# Product Change Notification

**Change Notification #:** 105937 - 00  
**Change Title:** Intel® NetStructure® MPCHC0001 14U, PCN 105937-00, Product Design, Fan Tray overlay change  
**Date of Publication:** February 16, 2006

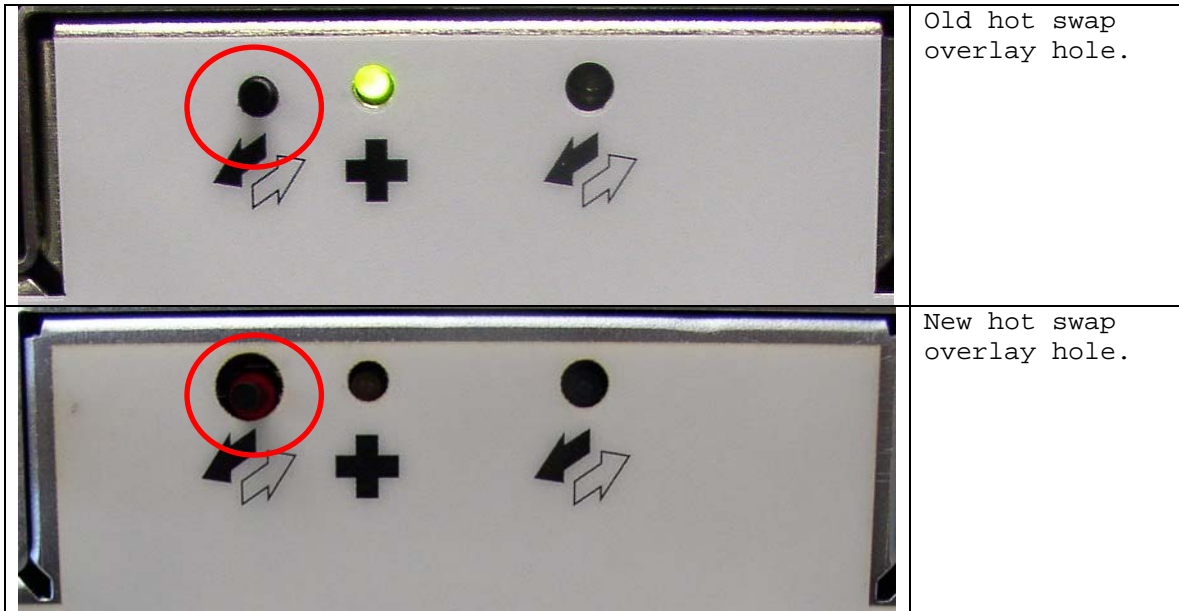
A MPCHC001 fan tray improvement: enlarged overlay radius circular hole around the hot swap switch to better match the dimension of the sheet metal hole.

Customers can expect to receive fan trays with both the smaller hot swap overlay hole and the larger overlay hot swap hole.
